Agenda Item 1: Review of the Responses to the Technical-Economical Request for Proposal (RFP) for the MEVA II/REDDIG Interconnection

**RESPONSE FROM THE MEVA II SERVICE PROVIDER
REGARDING THE MEVA II / REDDIG RFP**

***Answers to the New Additional Questions by the MEVA II Service Provider
on the MEVA II / REDDIG RFP
(received on 27 September 2007)***

Venezuela - Station Rack

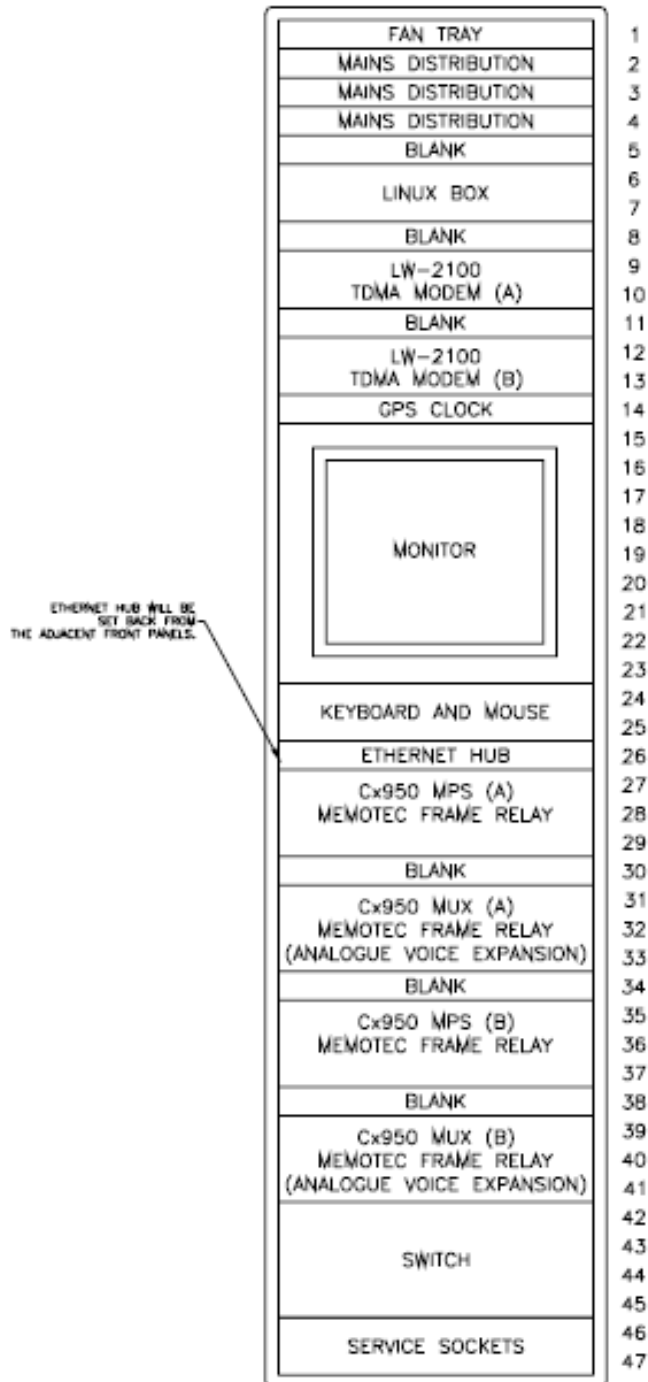
3) How much open rack space is available at the REDDIG Interconnect sites?

6) Please provide a block diagram of Colombia and Venezuela that shows switching between components.

Answer: Please see attachments at this respect.

Answer: Please see the attachment at this respect.

* GPS Clock not installed
